AGENDA ITEM #2

TO: Design Review Commission
FROM: Steve Golden, Interim Planning Services Manager
SUBJECT: SC21-0023 – 959 Altos Oaks Drive

This is a design review application for a new two-story residence. The project includes a 2,733 square foot first story and a 987 square foot second story for a total floor area of 3,720 square feet. This project should be considered categorically exempt from further environmental review under Section 15303 of the California Environmental Quality Act since it involves the construction of one single-family residence in an area zoned residential uses. The following table summarizes the project's technical details:

Showing redwood tree #13

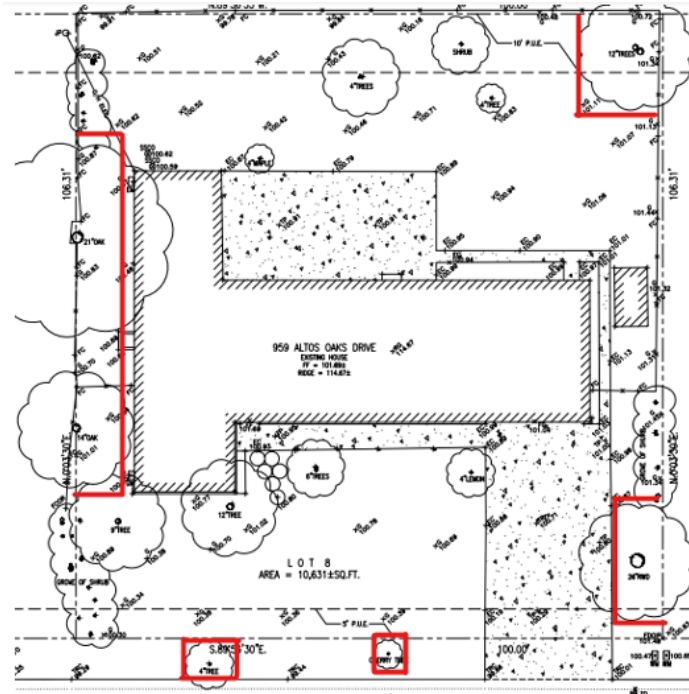
A new driveway is proposed at the same location as the existing driveway near redwood tree #13. The driveway will be a concrete driveway over 8 inches of base rock. All demolition/excavation for the driveway will need to be done by hand when underneath the redwood tree's dripline. Roots within the base rock layer are recommended to be retained by packing base rock around roots. The redwood tree is recommended to be irrigated every 2 weeks during the dry season.
